SONINA PROPERTIES APARTMENTS

SKETCH PLAN NO. 320250010

COMPLETED: 5/5/2025

Figure 6 – Site Access and Circulation

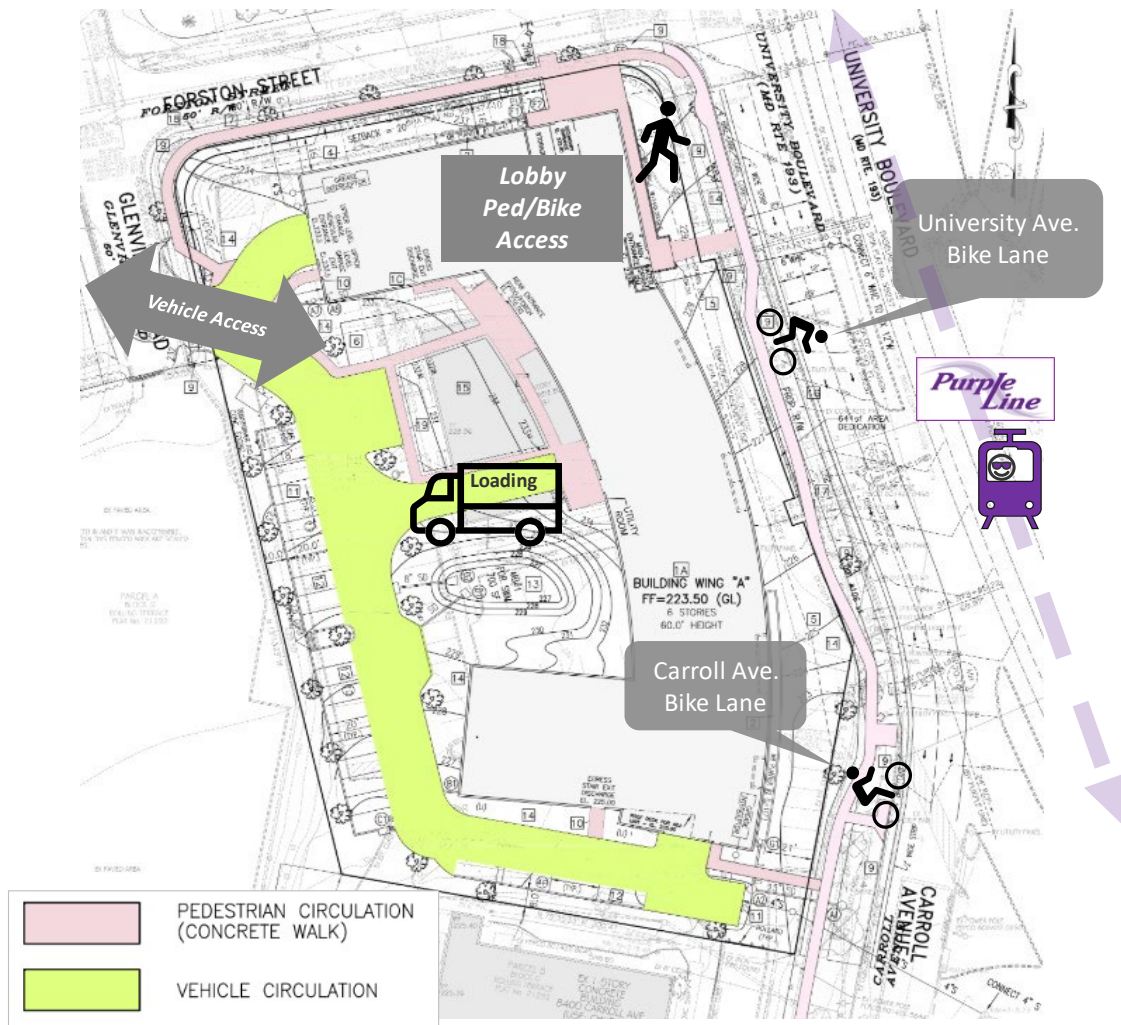
Existing site access and circulation access for all modes of transportation is currently centralized via a single curb cut to University Boulevard (MD-193). Secondary vehicular access points are provided by two private driveway connections with the church property to the south. The Project proposes closing the University Boulevard access and two driveway connections and consolidates all vehicular and loading access to Glenville Road (Figure 6).

Vehicular and loading access is consolidated to a single point at Glenville Road. From that point, an internal driveway splits to provide access to the northern parking structure in Wing B of the building, and to provide access to surface parking, loading space and internal parking structure under Wing A of the building. The Sketch Plan proposes 115 total vehicular parking spaces.
